Greensmaster® 1000 and 1600

Subject: Drive System becomes affected when Clutch Lever Stop bends.

Ref: 09-04 Copyright[®], 1997. The Toro Company

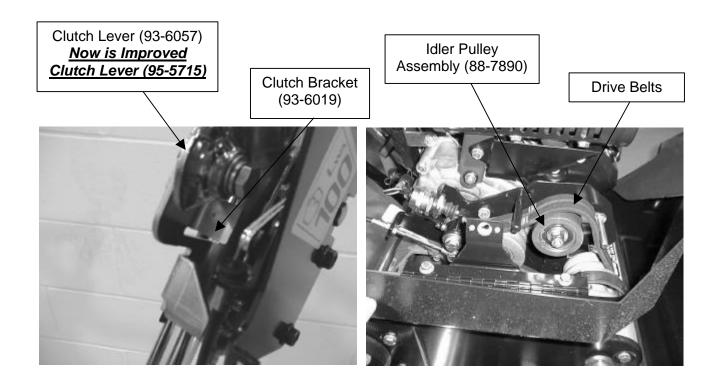
The stop tab on Clutch Bracket (93-6019) can bend if the operator uses excessive force to engage the Clutch Lever. A bent stop will allow the clutch lever to over-travel and cause the Idler Pulley to partially disengage the drive belts. A bent stop can result in drive belt slippage, accelerated belt wear, or poor drive system performance.

To help prevent the operator from using excessive force, Clutch Lever (95-5715) is now available for installation. The pivot location of the improved Clutch Lever has been relocated to lessen the forces that can be generated at the stop tab. The pictures below are provided for reference purposes. Contact your local Toro distributor if assistance with this repair is needed.

Note: We recommend replacement of Clutch Bracket (93-6019), if the stop has been bent.
